Accessibility Review Report – SSDA

Project Title: Mixed-Use Residential Development
40 The Retreat, Bringelly

Job Number: 23362

Date: 08 May 2024

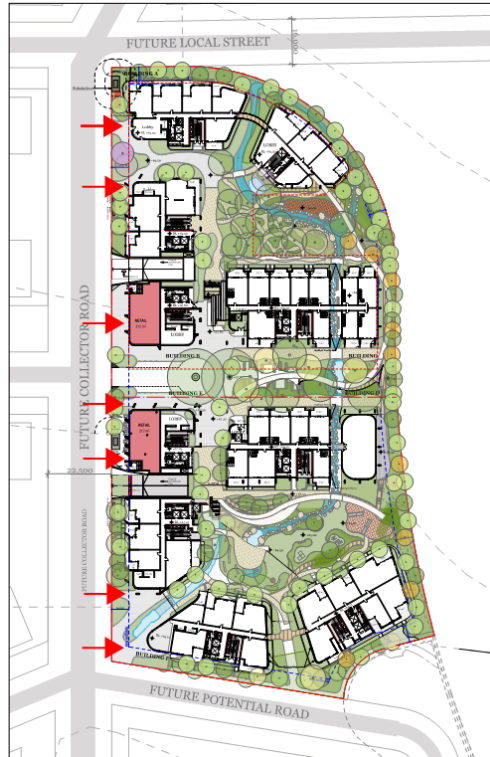
Multiple pathways are provided throughout the site providing an accessible path of travel between all buildings via a series of walkways, ramps and passenger lifts. The below figure indicates accessible landscaped pathways throughout the site shown in blue which links all parts of the development.

The pathway is connected by a series of ramps/ walkways and passenger lifts.

Figure 1 – STAGE 01 Ground Floor: Proposed Entrances to Building

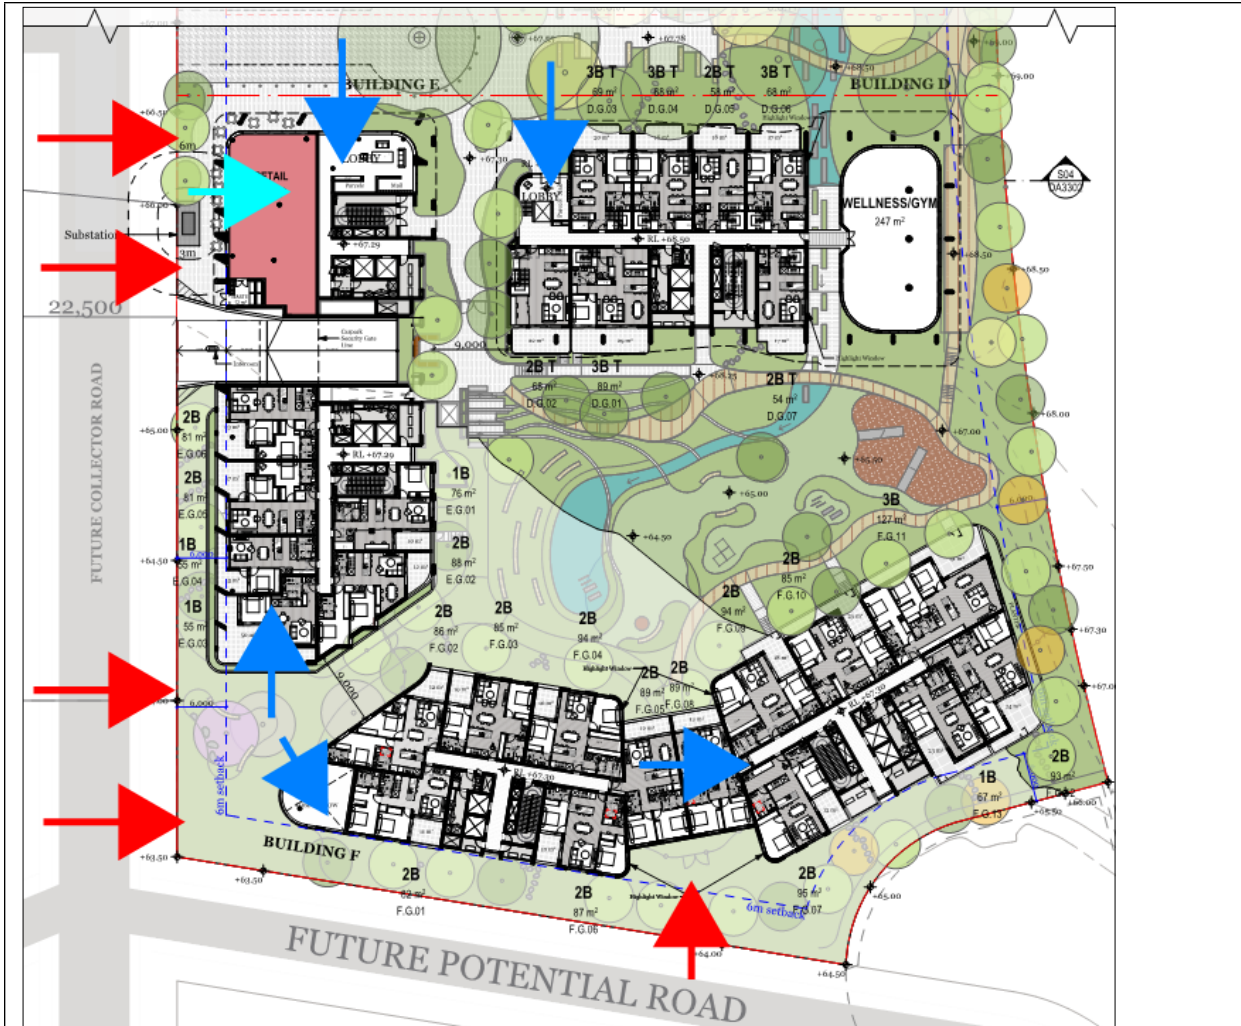
Principal Pedestrian Entrances (Building)

The following building portions are provided with entrances:

- Residential lobbies; and
- Retail Tenancies.

Ensure all principal pedestrian entrances (PPEs) and building entrances are compliant as prescribed by Cl. D4D3.

Further review of detailed building elements will be required as the design progresses.

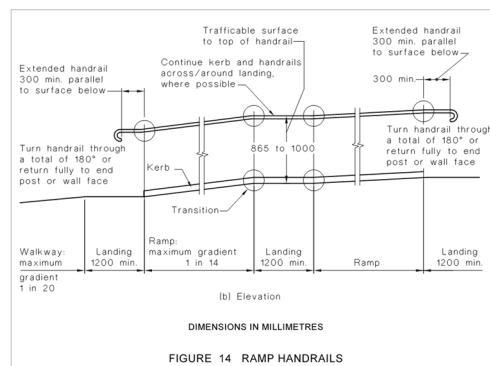
- Stage 1: External Ramp to retail tenancy
A 1:14 graded ramp is proposed. The ramp is readily capable of complying with the requirements of AS1428.1-2009.
Further review of the ramp will occur at detail design stage.
